INTRODUCTION

Chrysler A604

CHRYSLER A604 NEW 4 RING STATOR

Figure 15

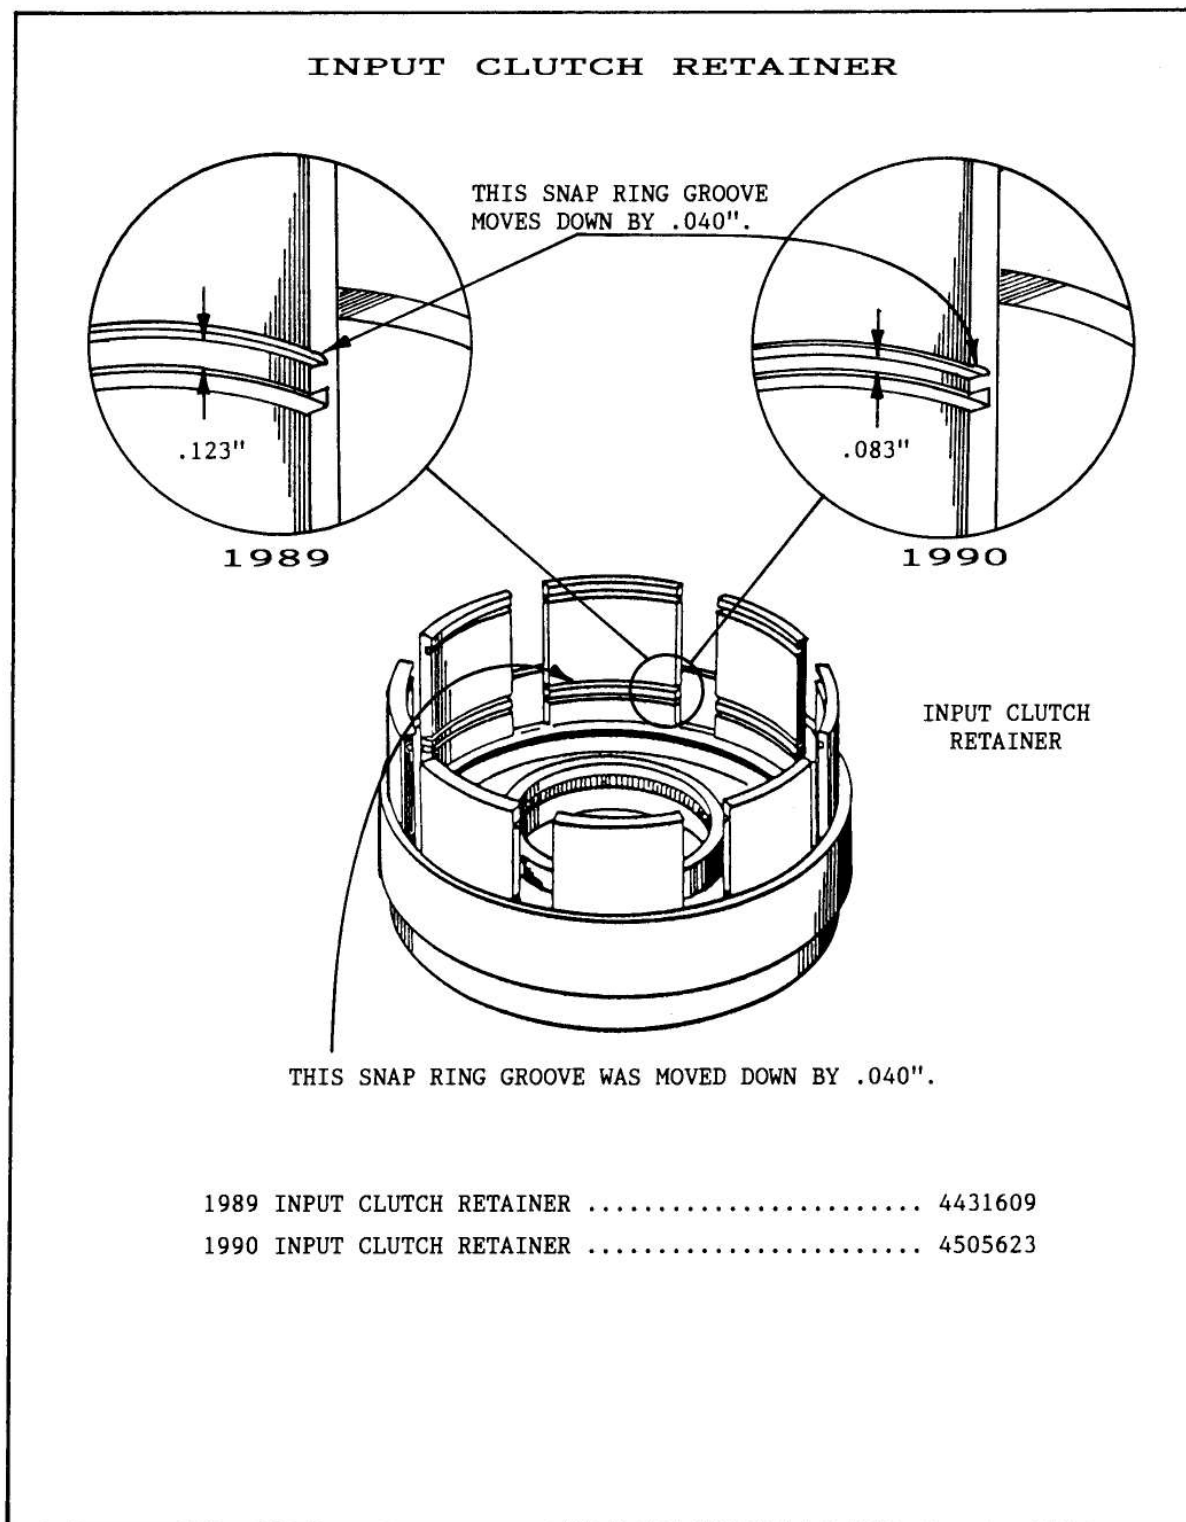
- (4) INPUT CLUTCH RETAINER - The underdrive/overdrive reaction plate tapered snap ring groove was moved "Down" by .040" (Can be Detected Visually) to accomodate the thinner underdrive/overdrive reaction plates (Figure 15). Another change that occurred at the same time is the underdrive clutch outer lip seal groove depth is .040" "Shallower" to accomodate a new underdrive clutch outer lip seal (See Figure 16).

Figure 16

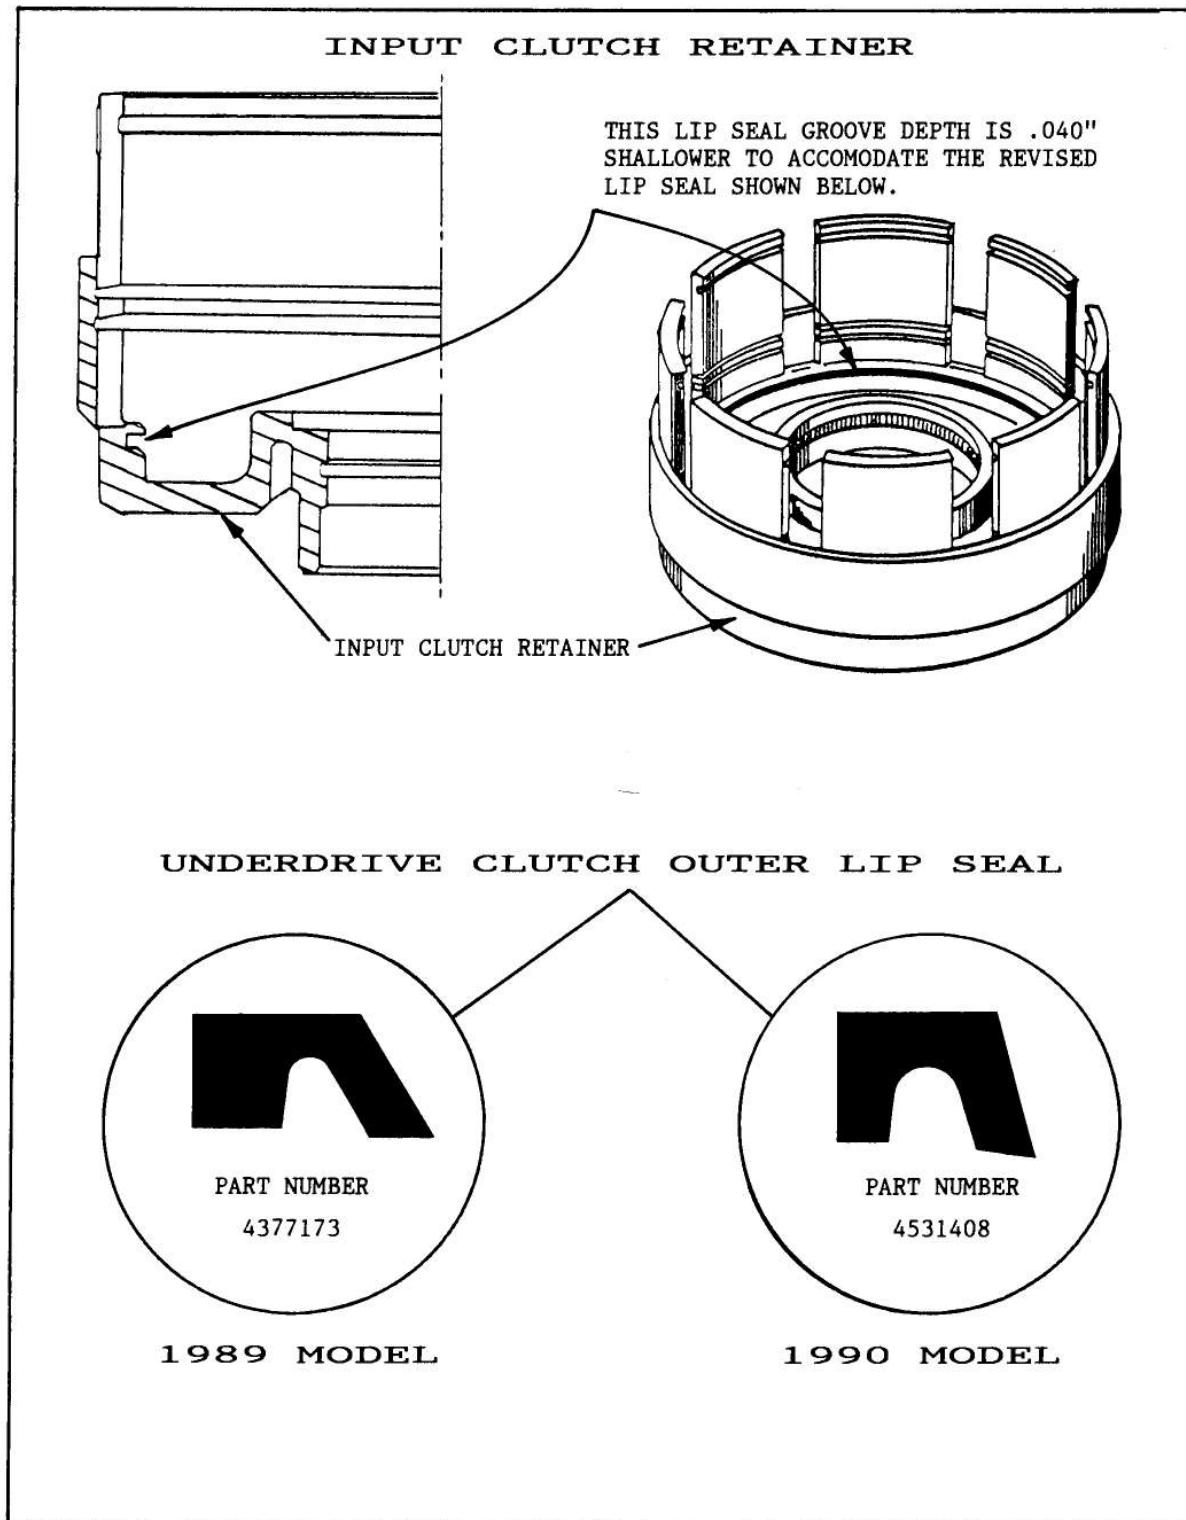
- (6) UNDERDRIVE CLUTCH OUTER LIP SEAL - The lip seal cross section has been reduced by .040" (Smaller in Overall Diameter) to accomodate the change in the depth of the groove in the input clutch retainer (See Figure 16). The OEM part number is printed on the seals for identification. The 1989 (Large) is 4377173, and the 1990 (Small) is 4531408. This will confirm that you have the proper seal for this location (See Figure 16).

FIGURE 18

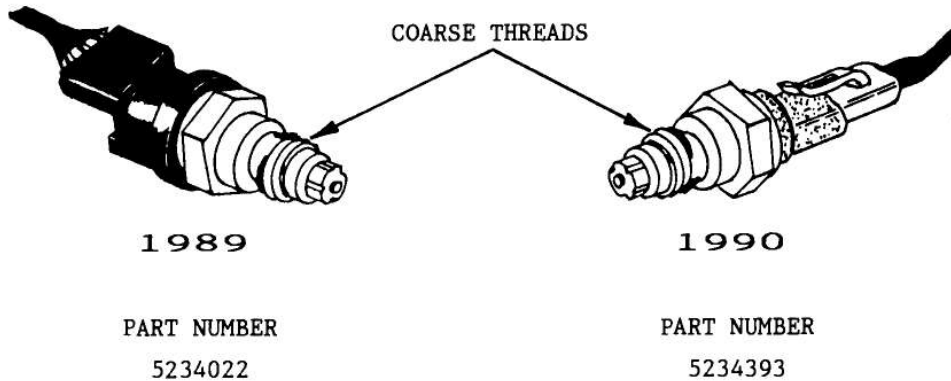
- (1) **PRNODL SWITCH AND CONNECTOR** - The PRNODL Switch and its wiring harness connector have changed for 1990, and can be identified visually (See Figure 18). These PRNODL Switches WILL NOT interchange with one another.
- (2) **NEUTRAL SAFETY SWITCH AND CONNECTOR** - The Neutral Safety Switch and its wiring harness connector have changed for 1990, and can be identified visually (See Figure 19). These Neutral Safety Switches WILL NOT interchange with one another.

THESE PRNODL SWITCHES WILL NOT INTERCHANGE.

FIGURE 19

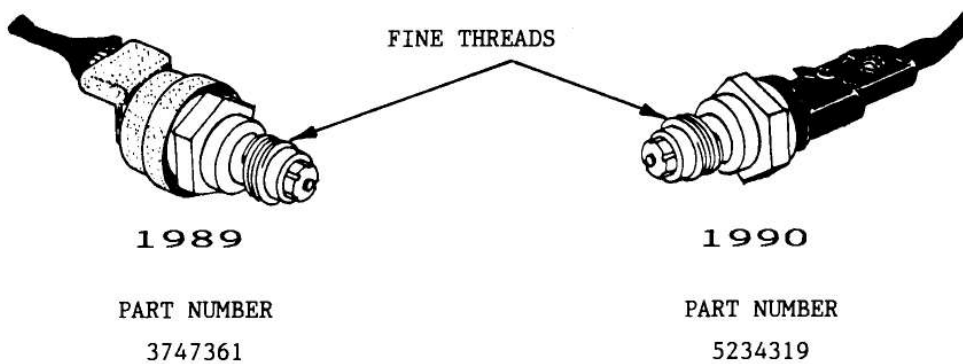
THESE NEUTRAL SWITCHES WILL NOT INTERCHANGE.

Figure 25

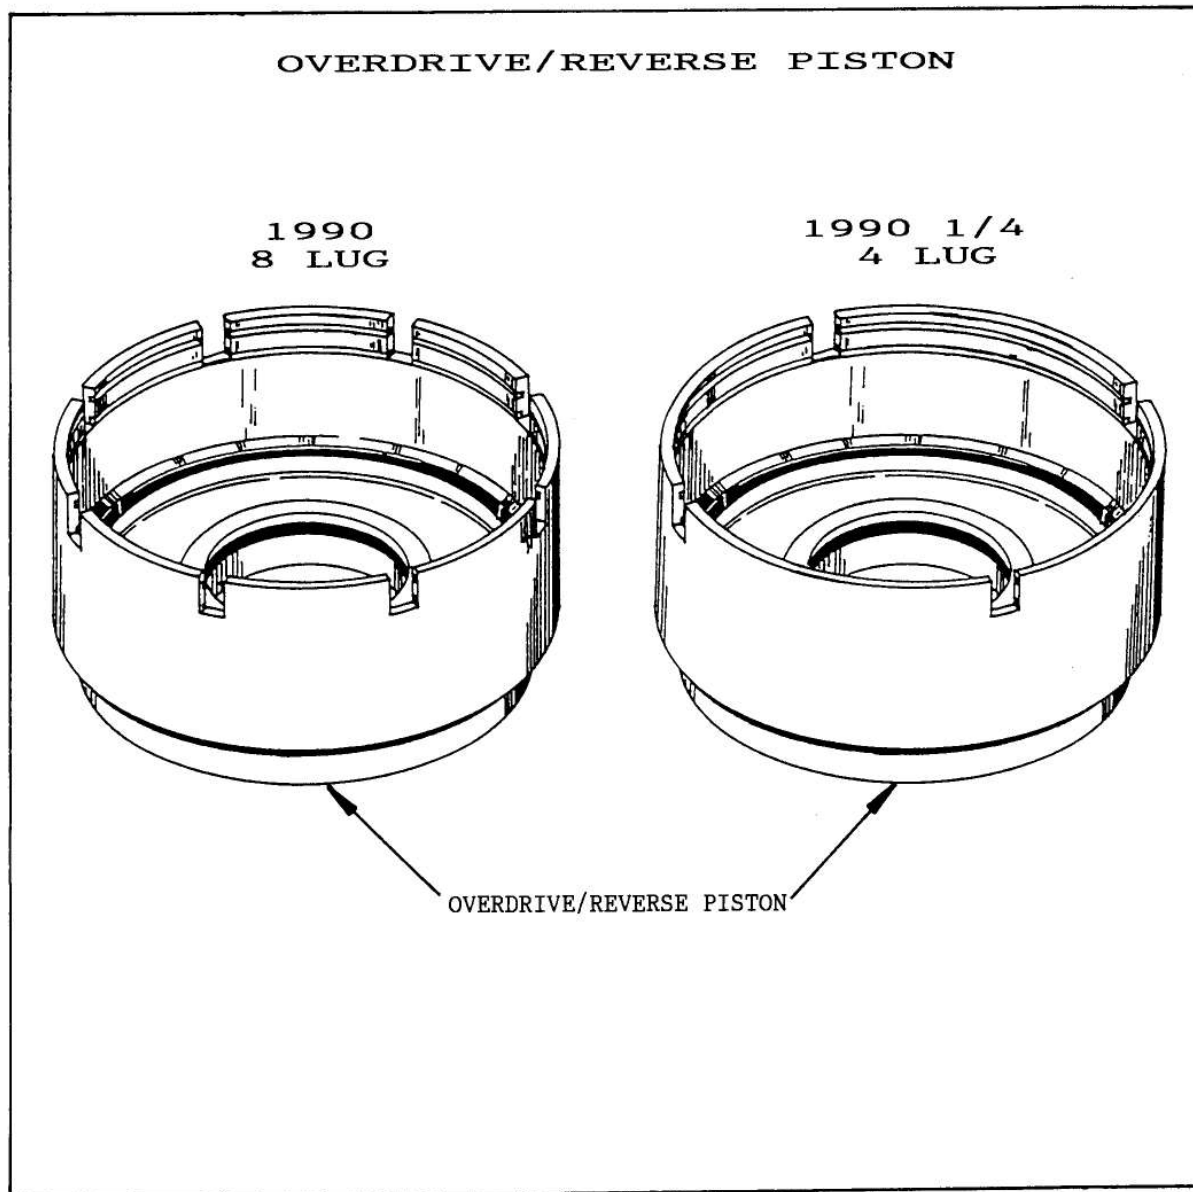
CHANGE: A new Overdrive/Reverse Piston has been introduced for 1990 1/4 model transaxles, and features four reaction plate slots instead of eight slots (See Figure 25).

- (1) OVERDRIVE/REVERSE PISTON - The new Overdrive/Reverse Piston has four slots, for the pressure plate lugs, instead of the previous eight slots and can be identified visually (See Figure 25).
The inside diameter of the new pistons bottom corner also has a larger radius to accomodate a new 1990 1/4 Input Clutch Retainer dimensional change (See Figure 26).
- (2) OVERDRIVE/REVERSE PRESSURE PLATE - The new Overdrive/Reverse Pressure Plate has only four lugs on the outside diameter, instead of the previous eight, and can be identified visually (See Figure 27).
- (3) INPUT CLUTCH RETAINER - The new Input Clutch Retainer has a new radius on the outside diameter, to reduce the chance of damage to the lip seal during assembly (See Figure 28). This retainer has no identification marks, and is tough to identify visually. The OEM part number did not change.

The new Overdrive/Reverse Piston, and four lug pressure plate will retro-fit back to all previous models, if it is used as an assembly. The piston and pressure plate must BOTH be used in these instances. The revised Input Clutch Retainer WILL NOT work with the previous style 8 lug overdrive/reverse piston. Since the part number did not change, to replace an input clutch retainer built in 1990, before the change to the 4 lug overdrive/reverse piston, you MUST also change to the 4 lug design piston and pressure plate.

Figure 28

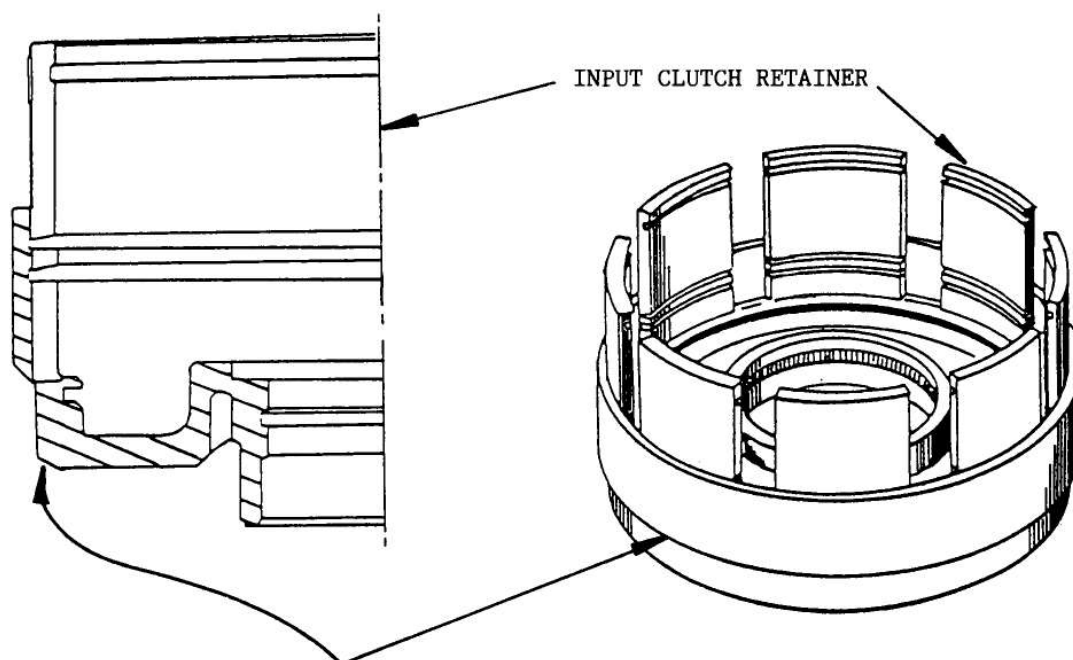
1990 1/4 INPUT CLUTCH RETAINER HAS A REVISED RADIUS, LOCATED HERE, ON THE OUTSIDE DIAMETER TO REDUCE THE CHANCE OF DAMAGE TO LIP SEAL.

Figure 29

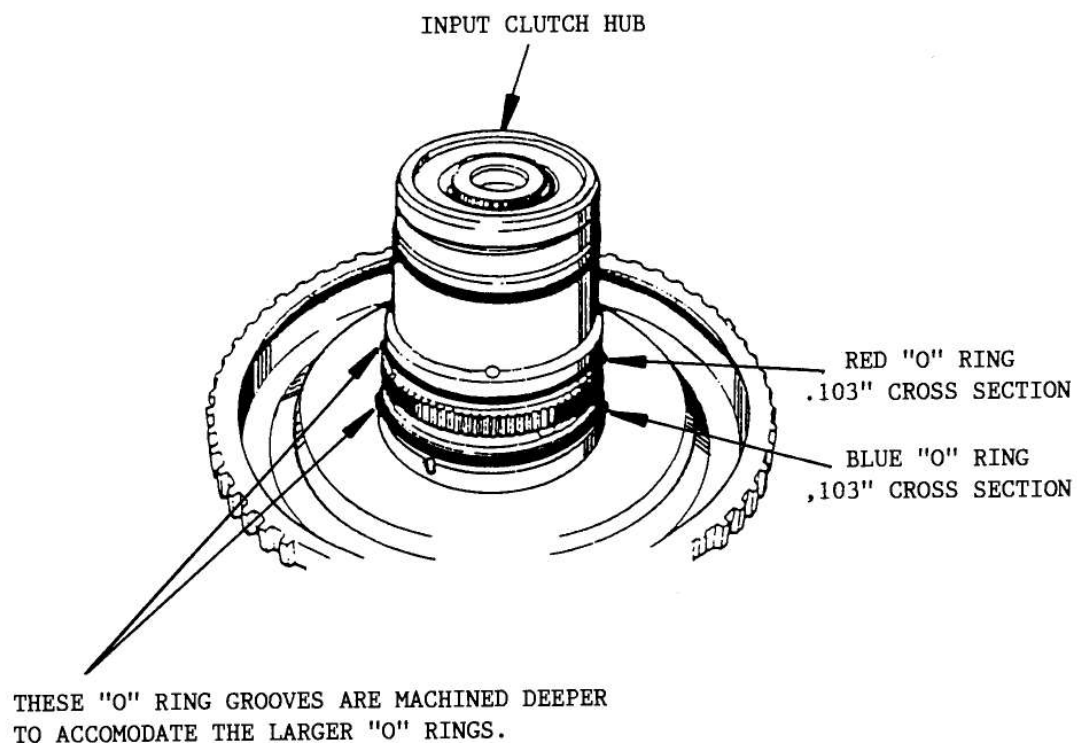
- (1) INPUT CLUTCH HUB - The "O" ring grooves on the Input Clutch Hub are cut deeper to accommodate the larger cross section color coded "O" rings (See Figure 29).

Figure 30

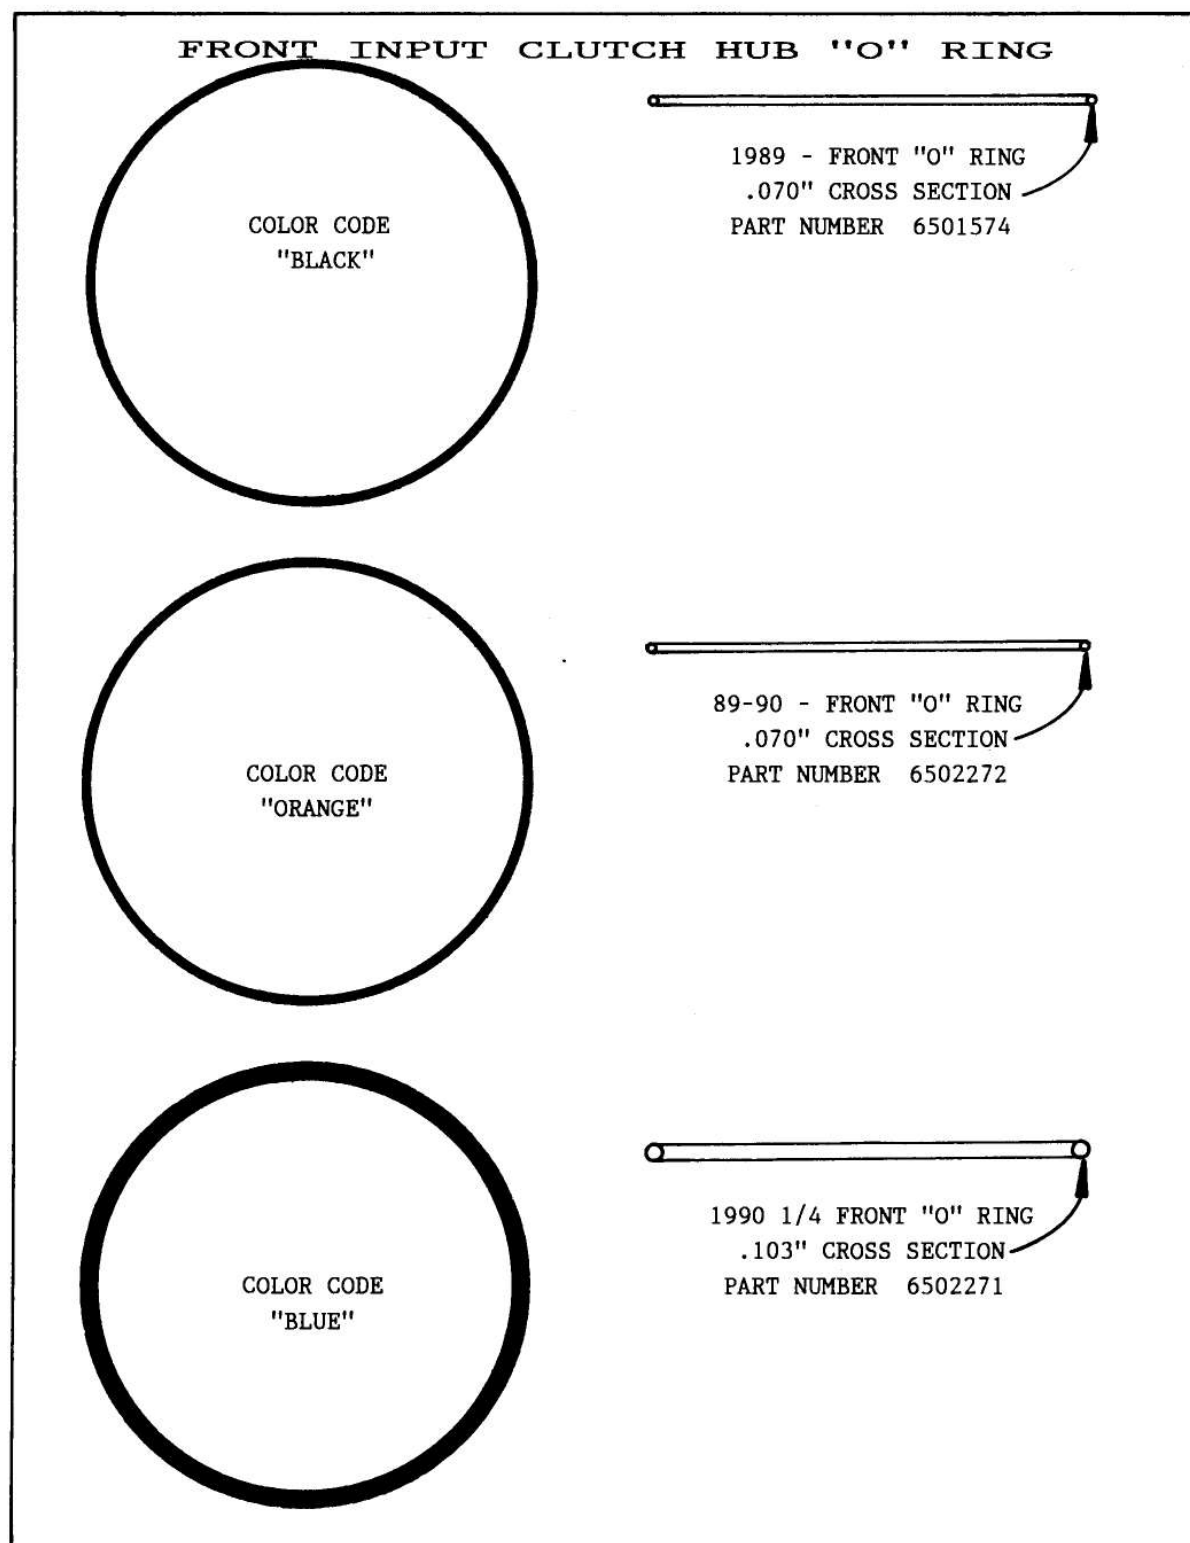
- (2) FRONT INPUT CLUTCH HUB "O" RING - This "O" ring now has a larger, .103" cross section and is color coded BLUE for identification purposes. Remember that this is the 3rd change on this "O" ring. The original "O" ring was BLACK with a .070" cross section, the 2nd design "O" ring was ORANGE with a .070" cross section, and the 3rd design "O" ring is BLUE with a .103" cross section (See Figure 30).

Figure 31

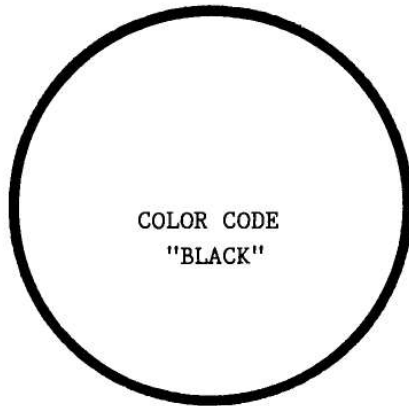
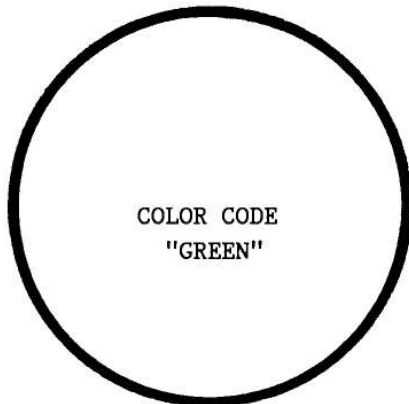
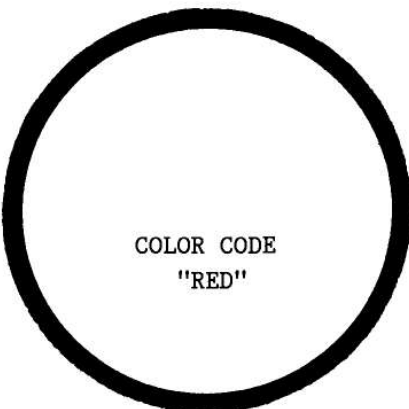
- (3) REAR INPUT CLUTCH HUB "O" RING - This "O" ring now has a larger, .103" cross section and is color coded RED for identification purposes. Remember that this is the 3rd change on this "O" ring. The original "O" ring was BLACK with a .070" cross section, the 2nd design "O" ring was GREEN with a .070" cross section, and the 3rd design "O" ring is RED with a .103" cross section (See Figure 31).
